CATEGORY 2.IMPROVED SEALING OF THE SCINTILLA CHOKETHERMAL DELAY SWITCH

No. S2/M1

No. S2/M5

No. S2/M9

Fig.3. 'A' Fuse Clips set Incorrectly.  
'B' Correctly.

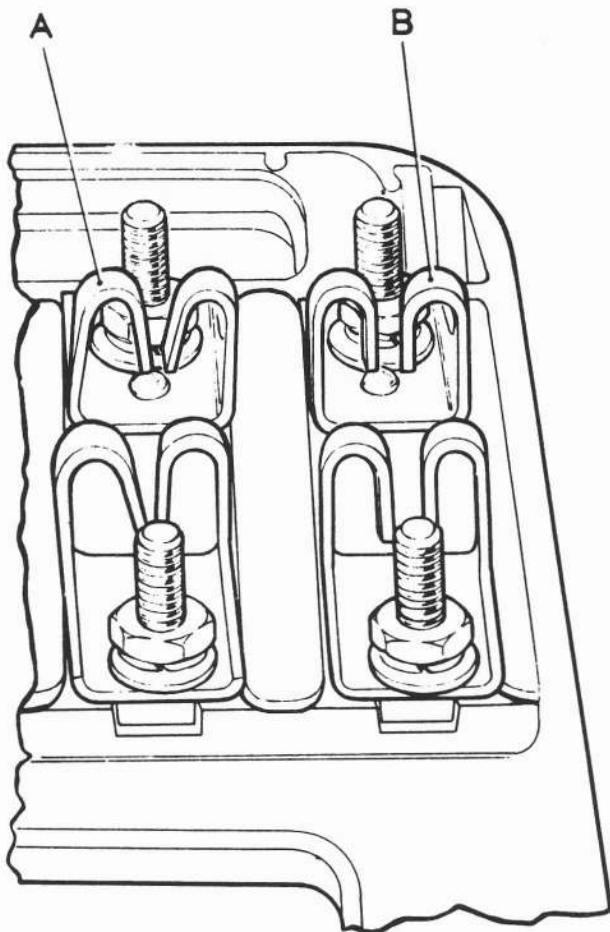
ATTENTION TO FUSE CLIPS

Ensure that the fuse clips are not distorted. They should be set square and parallel in order to maintain the holder firmly in position.

Figure 3 shows a comparison between the fuse clips set correctly and incorrectly.

Fig.1. Method of Modifying the Fuse Holder

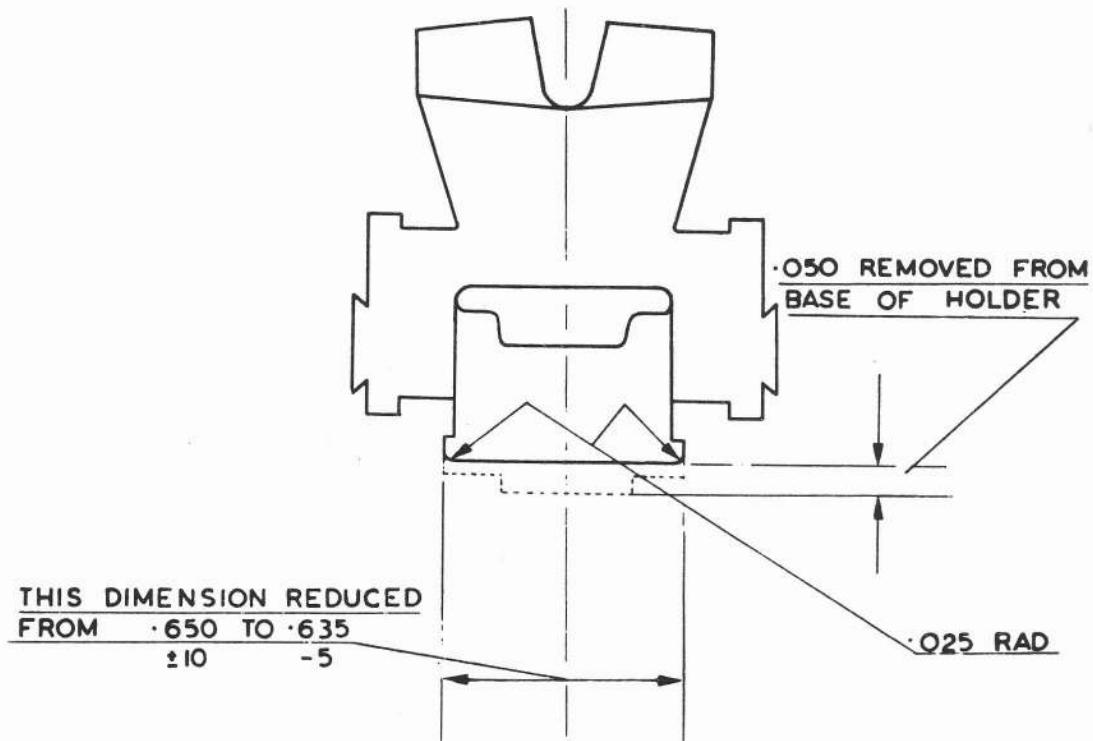
On late S1 cars and certain S2 cars, failure of the fuses to make good contact may be due to the fuse wires being located too high in the fuse clips. This fault can be attributed to one of the following causes.

- (a) Dimensional differences which produce a foul between the base of the fuse holder and the fuse clips, thereby preventing the holder from being pushed fully down into the clips.
- (b) The copper contact strips being incorrectly fitted, do not locate correctly on the moulding, which means that unless the fuse is carefully assembled the wire makes poor contact.

FUSE HOLDER - TO MODIFY

Remove .050 in. from the bottom of the fuse holder and reduce the width of the bottom to between .630 and .635 as shown in Figure 1.

This allows the position of the fuse wire to be lowered from .425 in. to .375 in. and enables the fuse holder to fit fully down between the clips.

Fig.2. 'A' Correct Method of Fitting the Fuse Wire,  
'B' and "C" Incorrect Method

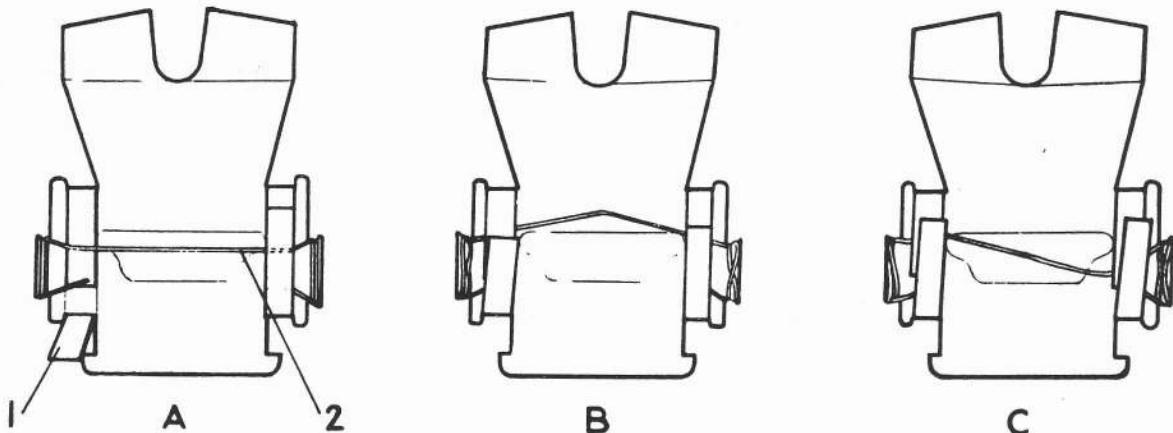
METHOD OF FITTING FUSE WIRE

It is important, when fitting the fuse wire, that the correct method is adopted.

Fit the copper strips to the fuse holder so that the fuse wire is firmly trapped and that each end of the copper strip overlaps the wire by an equal amount. The correct method of fitting the fuse wire and the contact strips is shown in 'A' of Figure 2.

Ensure that the wire is wrapped around the bollard on the fuse holder one and a half times, and passed across the air space along the ledge, parallel with the bottom of the holder, then wrapped around the other bollard one and a half times. The ends of the wire must be positioned so that they are securely trapped by the copper strips when they are fitted.

The correct method of fitting the wire is shown, in comparison with incorrect methods, in Figure 2.

Fig. 1. Positioning of Starter Motor Relay and Re-wiring of Connections

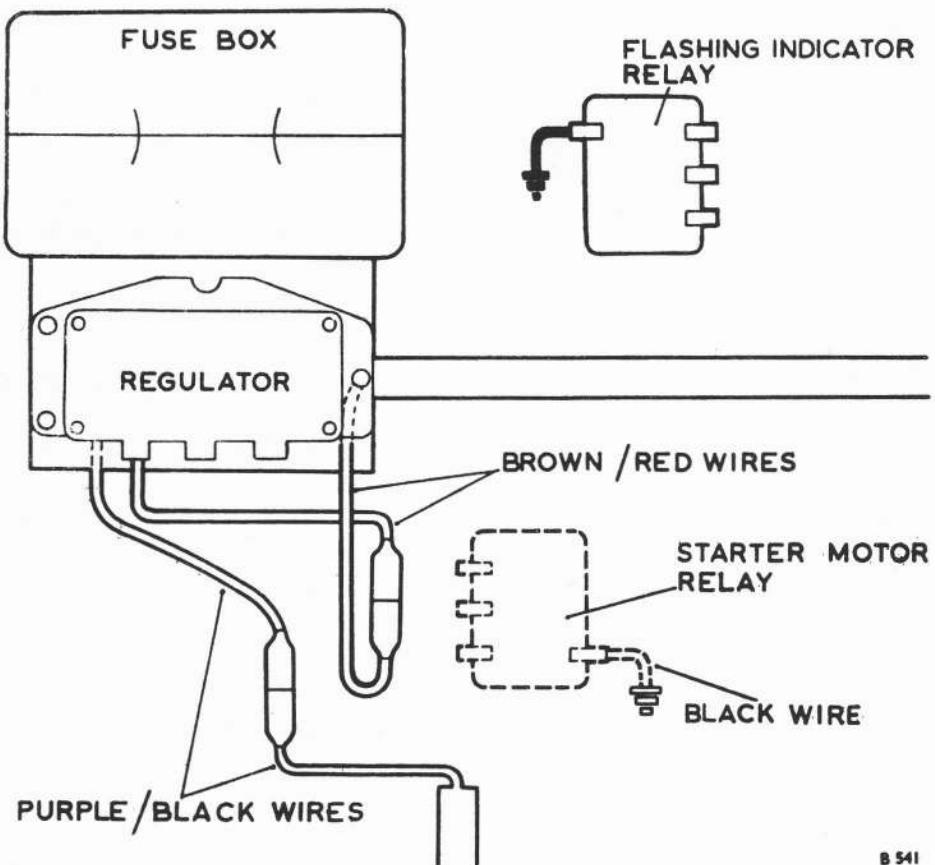
A protective device, in the form of a relay switch, was fitted to S2 cars to prevent drivers from engaging the starter motor pinion when the engine was running. Recent Service experience has shown that this relay does not function correctly and Retailers and Service Personnel should remove these relays when affected cars next come in for Service or in the case of customer's complaint.

If the engine cannot be started with the ignition key but will start when the rubber button on the solenoid is depressed then the relay is not working.

connector (UD.6074), (See Fig.1).

Remove the two Purple/Black wires from the connections C.2 and C.3 on the relay and connect them together using another double-ended connector (UD.6074).

Remove the Black earthing wire from the connection W.2 on the relay and from the bulkhead.

Remove the relay. The two cheese-headed screws and washers should be refitted to the bulkhead.

Remove the two Brown/Red wires from the connection W.1 on the relay and connect them together using a double-ended 'Lucar Blade'

Figure 1. Direction indicator switch (UR 16530)

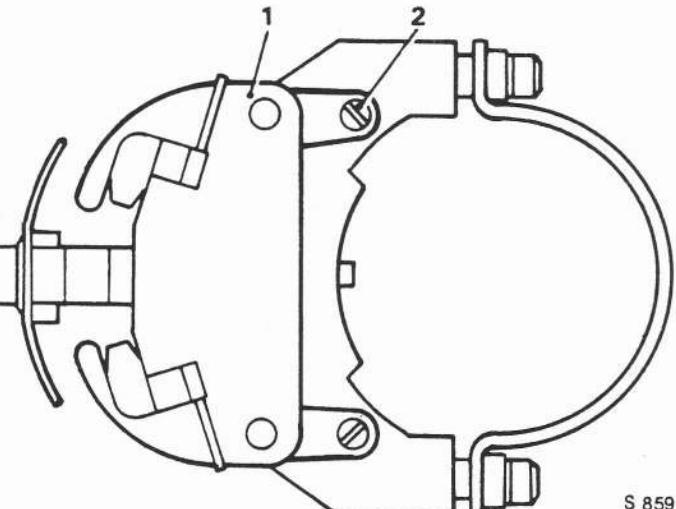
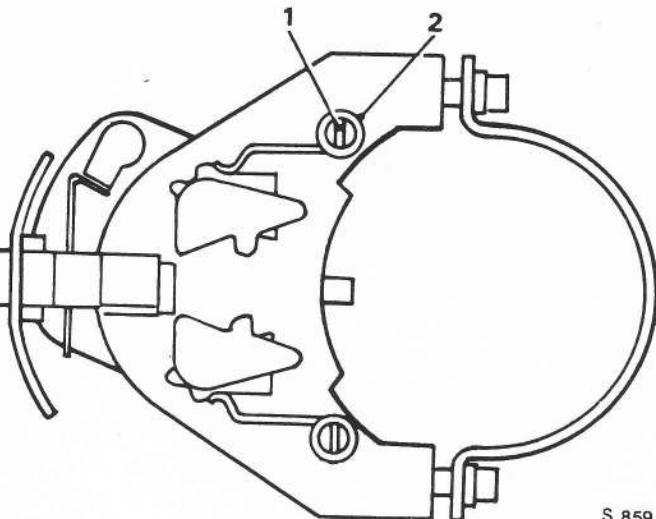
The direction indicator switch UR 5273 is no longer available. For replacement purposes, the switch used on Silver Shadow cars (UR 16530) will be fitted. When it is fitted, the terminal connectors must be changed.

1. The removal and replacement procedure for the new switch remains the same as for the old. However, there is a small modification to be carried out on the new switch as follows:
2. Remove the two screws and discard the brown insulation board (see Fig. 1). Replace the screws with a washer (X 4401) behind each screw head (see Fig 2).
3. Cut the 7 pin plug off and withdraw the insulation board along with the green/yellow and green/blue wires.
4. Fit 'Lucar' connectors to all the wires except the black one to which a bullet connector is fixed. Connect the wires as follows.
